1.1 Company	 STMicroelectronics International N.V
1.2 PCN No.	ADG/23/14471
1.3 Title of PCN	Redesign of the NTL00 and NTL20 resistor dice and transfer from CT6 (Catania) to SG6 (Ang Mo Kio - Singapore) fab
1.4 Product Category	RF Power
1.5 Issue date	2023-12-13

**Product/process change notification:**  
**Redesign of the NTL00 and NTL20 resistor dice**  
**and transfer from CT6 (Catania) to SG6 (Ang Mo**  
**Kio - Singapore) fab**

**PCN # ADG/23/14471**  
Qualification report

## New Resistor \_Top Layout : NTL10

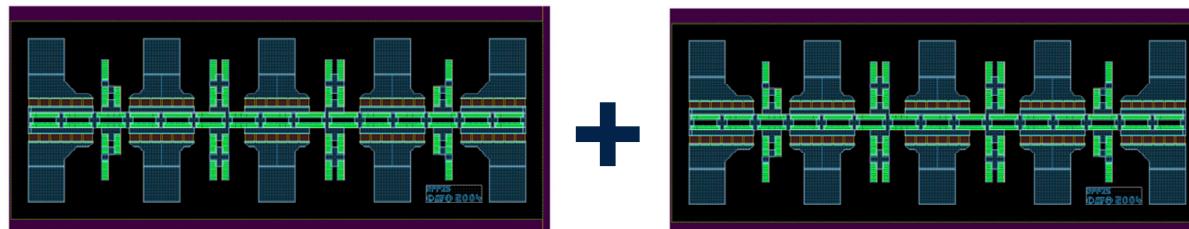
**Note** : the differences between new and old resistor consists in a single die , instead of 2 close together.  
Furthermore, the new version contains some marks for automation assembly system.

## New Resistor\_Top Layout : NTL21

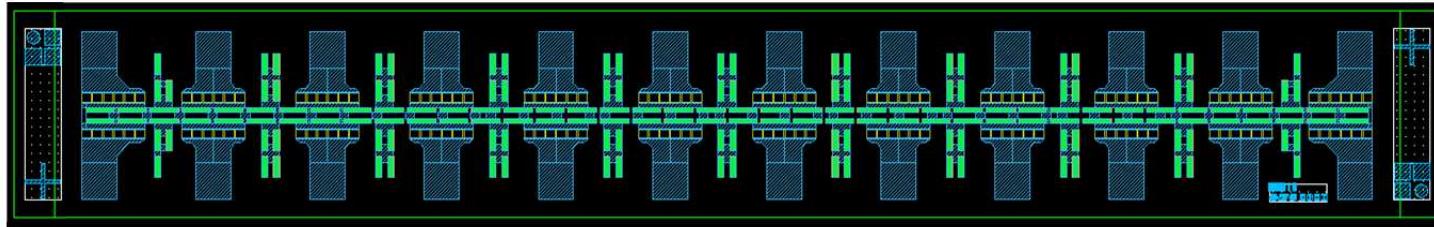
**Note** : the only differences between new and old resistor consists in a die size increase, to allow the marks introduction for automation assembly system.
